This is reference to the final Office Action for Application No, 10/621,487 Art Unit 3676. Please let me discuss Frey's Patent No. 1,034.008, dated July 30, 1912, by which you have rejected my patent locking claims.

S. FREY.
GRAVITY HINGE.
APPLICATION PILED JUNE 16, 1011.

Fig. 6 - 7 (a,b and c = 120 degree)

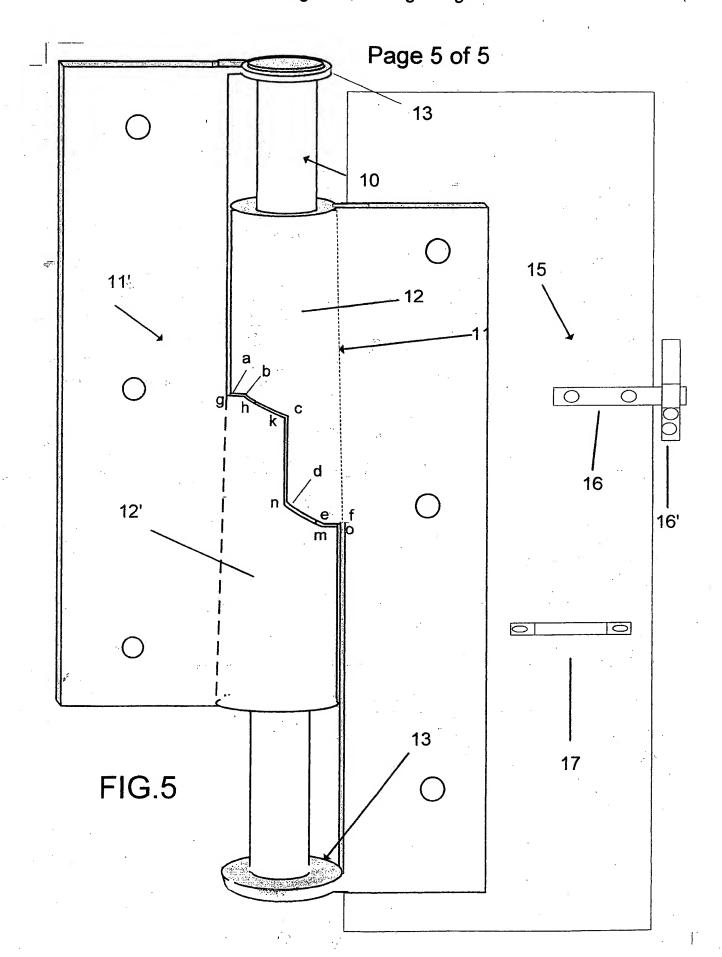
Frey's drawing Fig.6 (part 13), and Fig. 7 (part14), which are the base of his invention should complement each other, it never do so. They do not fit each other. I actually made a prototype of his figure. If one plane was made a complement of the other, then it will act as one-way self-closing hinge, as he claimed. Frey's drawings, on which you are rejecting my invention, is incorrect.

Frey's drawings are based on imagination not on protetype .

This formal controls (3(a) = 1.4(b) 13(b) - 14 (a) 13(c) = 14 (c) to fit together

Frey's 13 (a) is 140 degree how it could fit to 14(b)=40 degree 15(a)=14(a) 13(b)=14(b)

Fig. 6 or one of them should be like This The complement

Corrected 13-14

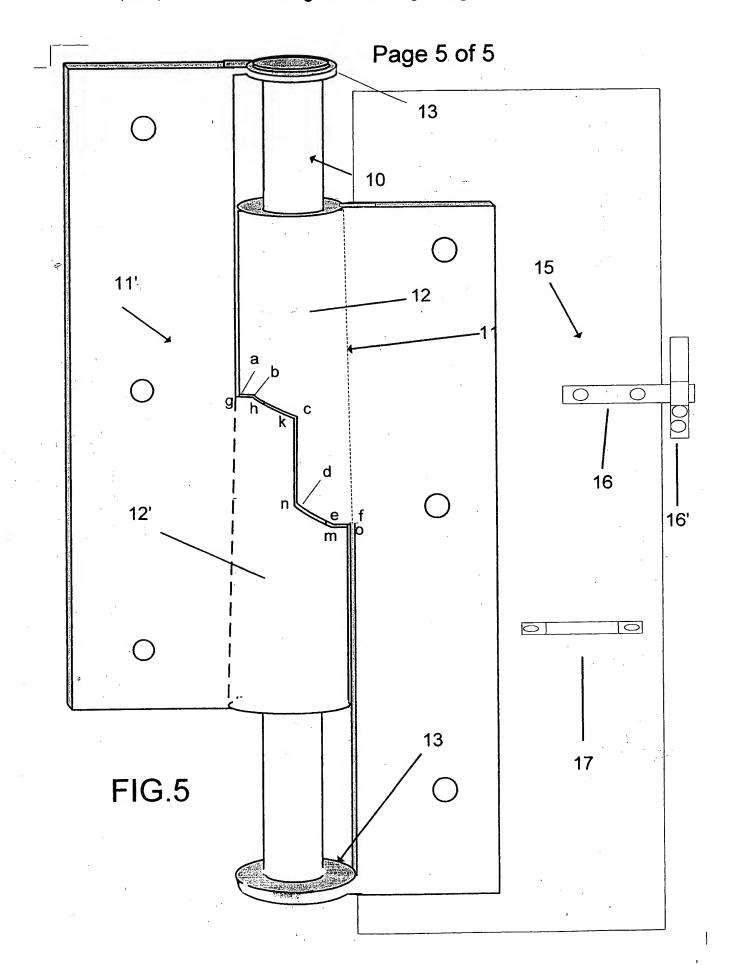
Frey's drawing Fig.6 (part 13), and Fig. 7 (part14), which are the base of his invention should complement each other, it never do so. They do not fit each other. I actually made a prototype of his figure. If one plane was made a complement of the other, then it will act as one-way self-closing hinge, as he claimed. Frey's drawings, on which you are rejecting my invention, is incorrect.

Frey's drawings are based on imagination not on prototype,

This formula control's 13(a) = 14(b) 13(b) = 14 (a) 13(c) =14 (c) to fit together

Frey's 13 (a) is 140 degree how it could fit to 14(b)=40 degree 19(a)=14(a) 13(b)=14(b)

Fig. 6 or one of them should be like This The complement
